IN THE DRAWINGS:

Please cancel Figure 2 of the drawings currently on file and replace it with the attached Replacement Sheet of revised Figure 2.

REMARKS

Figure 2

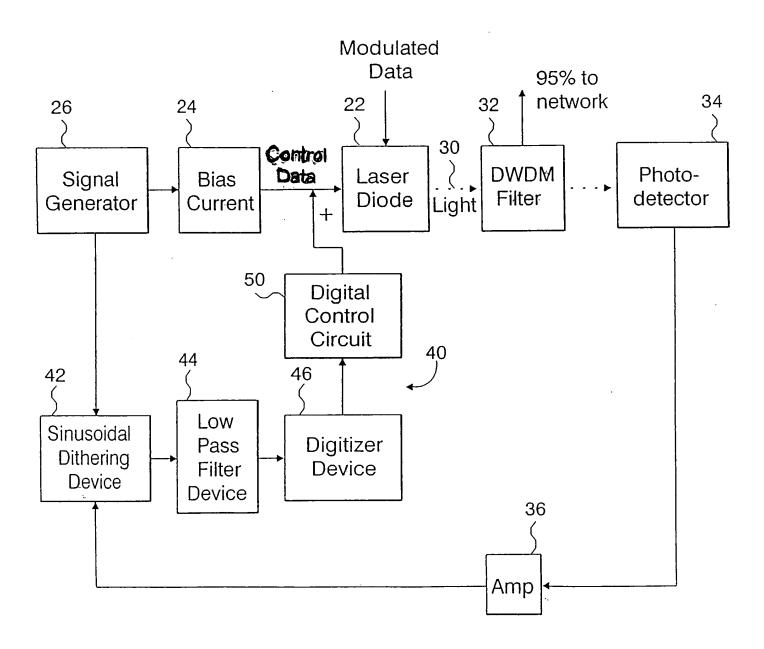
In addition, an amended Figure 2 is being submitted herewith to address the Examiner's objection to the drawings. More specifically, in the Office Action, the Examiner objected to the drawings as not showing "the modulation scheme to add the control data" to the optical signal, as recited in Claim 21. This control modulation scheme is shown in Figure 2, and discussed in the specification on pages 5 and 6.

In order to more clearly show this aspect of the invention in the drawings, Figure 2 is being amended to indicate expressly that the control data is applied to an input of the laser diode 22 - specifically, the input that receives the signal from bias circuit 24.
